City of Toronto – Parks Development & Capital Projects

# 25 Oakcrest CAG

## Community Advisory Group Meeting 1

Meeting Summary

## Design Option A

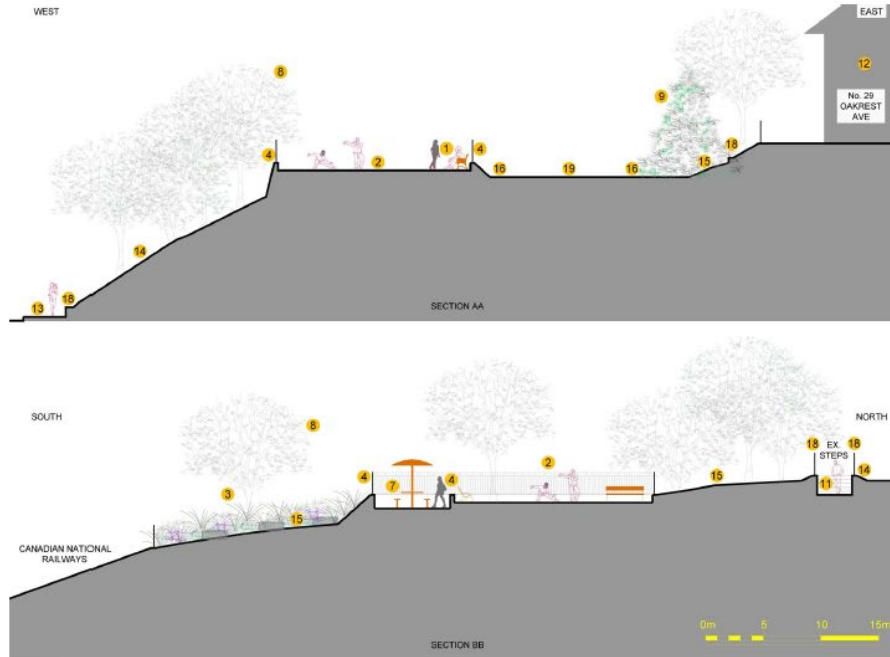
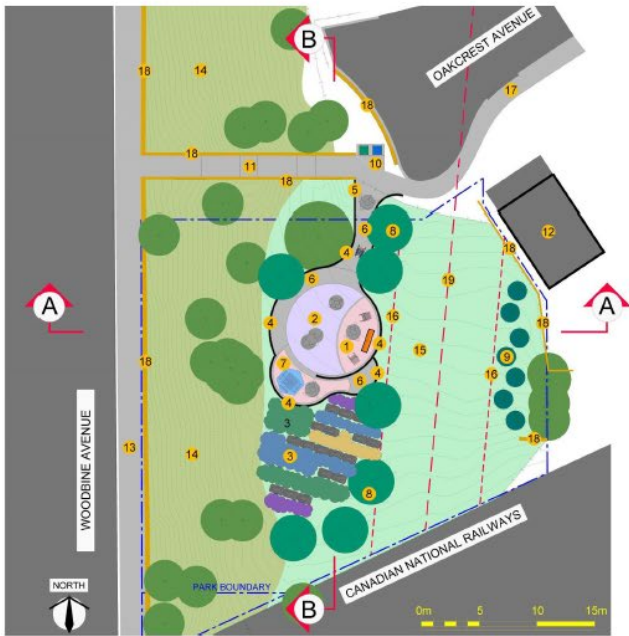
**Q:** Is the "#6 Accessible Walkways / Ramps" only within the park and towards Oakcrest Ave? Could it be added in addition to the "#11 Existing Stairs from Oakcrest to Woodbine? Based on what was presented, are there any leading down to Woodbine?

**C:** There already is a path from the top of the path. It would be a good idea to retain and uplift that path. The other side of the stairs might be more useful on Danforth and Woodbine.

**C:** Formalize the footpath people have created. And it's given that people take that path. Incorporate seating along the walls of the switchback.

**C:** The existing stairs are extremely steep and are a hazard in the winter. The objective should be to improve accessibility. But as seen, people are using a man-made footpath because there is a need for better accessibility - if we can do anything to improve it even if it is not perfect - I think that should be a priority. We would like to see an option that does work in the parameters we have.

**Q:** How could the 2 designs be better connected to 1) the West side of Woodbine (closest walking option is to walk down to Gerrard and around (450m) vs across the street (14m)), 2) the sidewalk on Woodbine south of the rail corridor (unpleasant walk under the bridge), and 3) the existing Oakcrest Parkette?

**Q:** What is the approx. square footage of the proposed flat space at the top of the design?

**Q:** Of the two plans, I prefer the one with the more circular flat area, it feels like it would fit better with a natural space. Is it possible to include a small fitness center in that format?

**Q:** Could gardens be accommodated over the storm sewer?

**R:** No, the slope to woodbine is too great for an accessible path within the property limits of 25 Oakcrest. The existing footpath (desire line) is not accessible and cuts across Metrolinx lands at the bottom of the hill.**C:** Aging population, and parents with strollers - I would happily lose park space if it needs an S shape. An accessible path would be amazing.

**R:** *Parks objectives are to connect users to new recreational facilities. The stairs and pedestrian accessibility from sidewalk to sidewalk is Traffic Services responsibility.*

**R:** The objective of the Parks, Forestry and Recreation is provide recreational facilities, parks and open spaces. Providing pedestrian connections, walkways and sidewalk would be a project

**R:** For both Option A and B – the flat spaces (seating, exercise and walkway areas) are approximately 100m<sup>2</sup> (1,100ft<sup>2</sup>).

**R:** The concepts are very preliminary and trying to identify program ideas. The aesthetic (square vs. round shapes) would be adjustable when detail design exercise is undertaken.

**R:** No infrastructure, permanent structures or trees are allowed on the storm sewer easement. Some planting might be okay, but not recommended because it would have to be removed at PFR's expense should Toronto Water have to undertake any maintenance.
